Delegated Report		Analysis sheet		Expiry Date:		21/01/2022	
		N/A / attached		Consultation Expiry Date:			
Officer				Application Number(s)			
Fast Track TC				2021/5791/P			
Application Address				Drawing Numbers			
Flat Ground Floor 97 King Henry's Road London NW3 3QX				Refer to draft decision notice			
PO 3/4		Area Team Signature		C&UD		Authorised Officer Signature	
Proposal(s)							
Widening of existing doorway and insertion of a door at rear first floor level.							
Recommendation(s):		Refuse planning permission					
Application Type:		Householder Application					
Conditions or Reasons for Refusal:		Refer to Draft Decision Notice					
Informatives:							
Consultations							
Adjoining Occupiers:		No. notified	00	No. of responses	00	No. of objections	00
				No. electronic	00		
Summary of consultation responses:		A site notice was displayed from 08/04/202 which expired on 09/05/2022.					
CAAC/Local groups* comments: *Please Specify		The Elsworthy Conservation Area Advisory Committee objected on the following grounds: "The proposed increase in the width of the existing opening makes the window too wide, out of scale with the building and is too close to the bay window. Objec

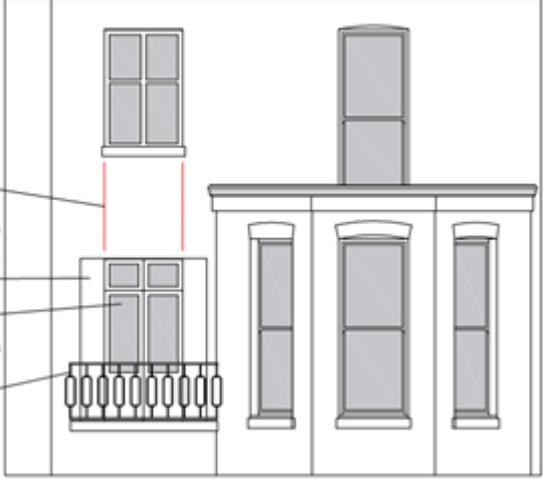
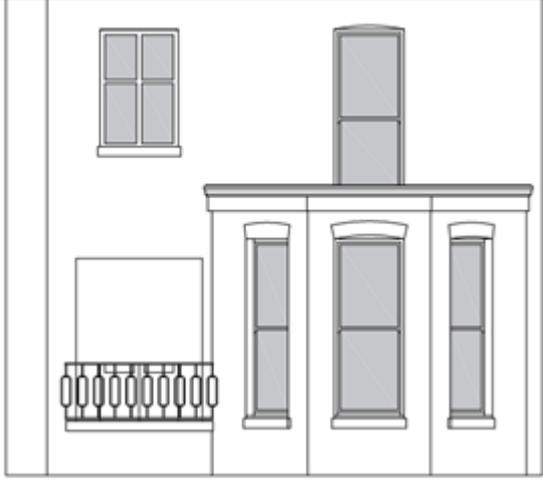
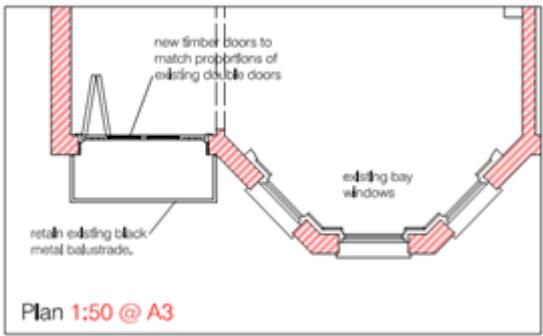
3.3 The proposals relate to an existing opening to the side of the bay window. The opening is currently French doors which open out onto the balcony. The proposal involves the widening of the door frame and the installation of a concertina door to allow for the opening of the door into the living room.

The proposed door visually features four panels, two wooden panels either side and two central glazed panels. The glazed elements would align with the width of the windows above. However, it would operate as a concertina doors with two panels (see drawing above). The Widening of the window opening would result in an opening wider than any others on the upper floors of the rear elevation of the property. When closed the window would feature wooden side panels which are not a feature of fenestration in this location. When open the width would appear out of keeping with the fenestration pattern at the property or the row of properties which is largely unaltered at first floor level and above. There is an example of an altered door at number 93 King Henry's Road, but this was not granted planning permission and appears to have been there for a number of years and would be immune from enforcement action. Despite this the terrace remains largely unaltered at this level.

Notwithstanding the concerns raised above the proposed timber material of the windows would be acceptable in terms of design and sustainability.

3.4 CPG Home Improvements states that for traditional buildings, metal railings are preferred as they integrate well with the building's character, are more resilient, require low maintenance and support plants growth. The agreement to retain the metal balustrade was an improvement on the original proposal. CPG Home Improvement goes on to say that glass balustrades could be appropriate for modern buildings with thin frames or frameless.

3.5 Overall the proposed widened concertina door fails to preserve and enhance the character and appearance of the host building, the street scape and the wider Elsworthy Conservation Area.

Reason for refusal: The proposed door and opening, by reason of its siting, design, width and opening mechanism would fail to preserve and enhance from the character and appearance of the host building and the wider Elsworthy Conservation Area. The proposal is therefore contrary to policies D1 (Design) and D2 (Heritage) of the London Borough of Camden Local Plan 2017.
